Access Compliance Report

Public Rights-of-Way

(Curb Ramps)

Intersection ID: 2959	Main Street: HARBURN_FOREST_DR	Cross Street: TUNSTON_LN	Location: SE
ADA ID: 038E5F498423	Ramp Type: PerpDiag	Initial Pass/Fail: Pass	Overall Compliance: No
		Severity Score: 17.5

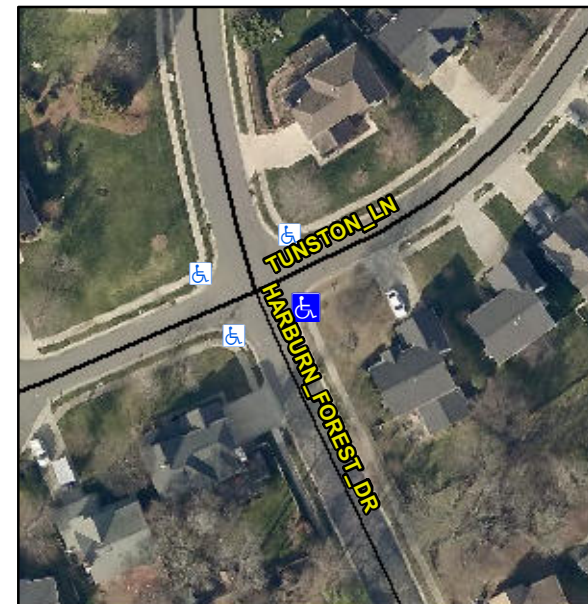
**Install Detectable Warning System.
Grind Gutter Lip.**

R305, R302.7.2
